DESIGN REVIEW BOARD DECISION ON DESIGN RESPONSE CONFERENCE APPLICATION

Date: January 24, 2013
File No.: DRV12-00921
Project Name: Lake Street Place
Applicant: Rick Chesmore with Chesmore|Buck Architecture

2 LANDSCAPE PLAN - PORTSMITH IMPROVEMENTS

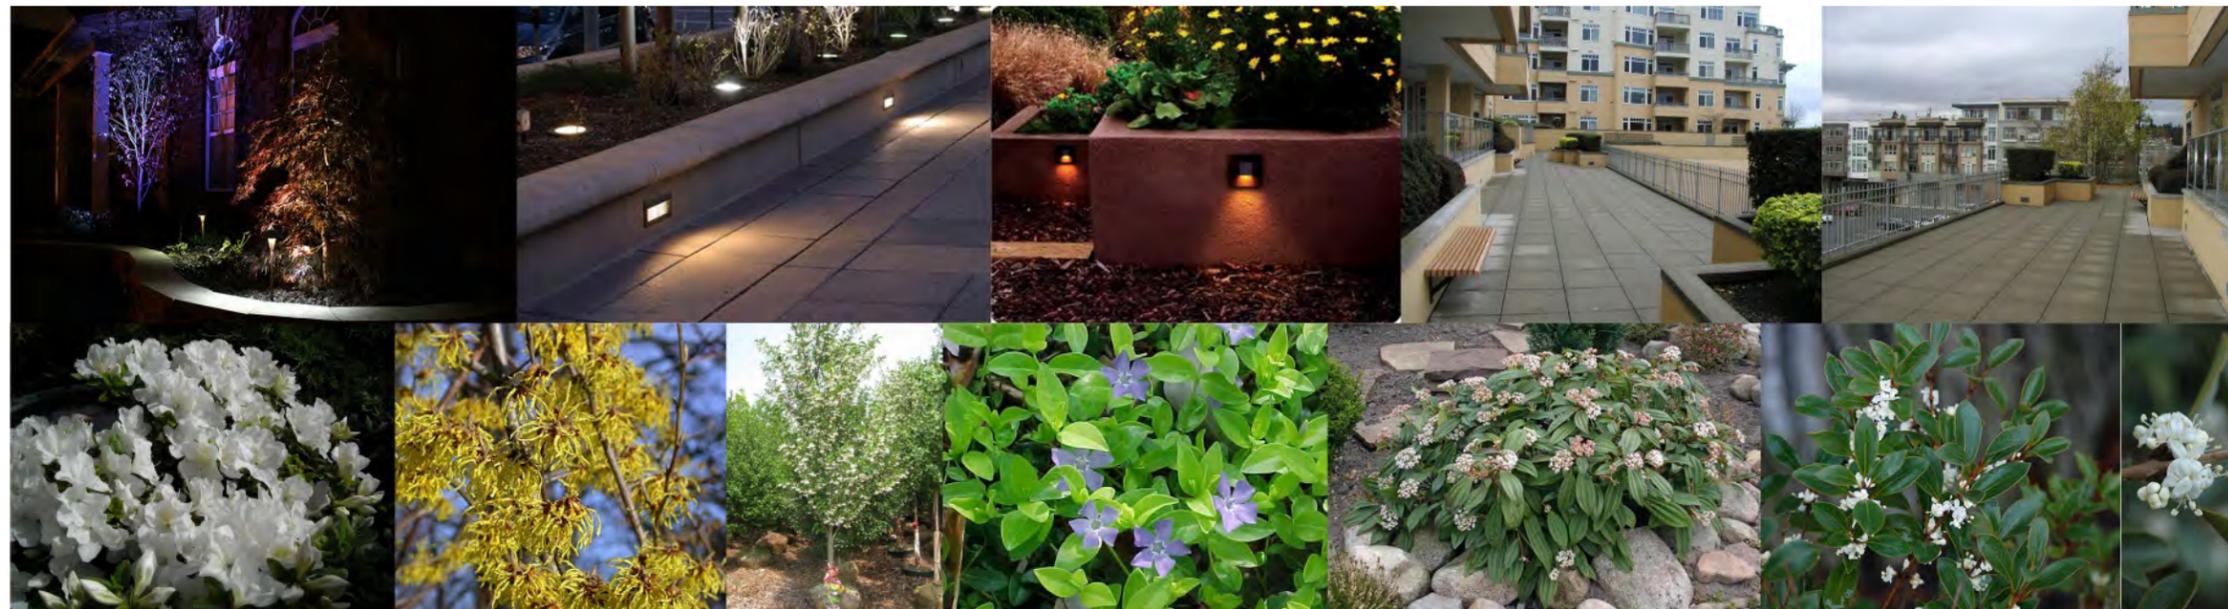
In regards to the planters proposed within the public pedestrian walkway on the Portsmouth property, it was understood that the DRB could not impose design requirements on a neighboring property. However, the DRB agreed that the planters would help soften the southeast façade of the Main Street building. The pedestrian walkway planters were proposed by the applicant and were based on discussions with Portsmouth and the desire by both parties to mitigate the

The DRB also concluded that if the landscape plan were to be subsequently modified in that the planters within the public pedestrian walkway were removed, the façade would still be consistent with the design guidelines given the smaller building scale at this area.
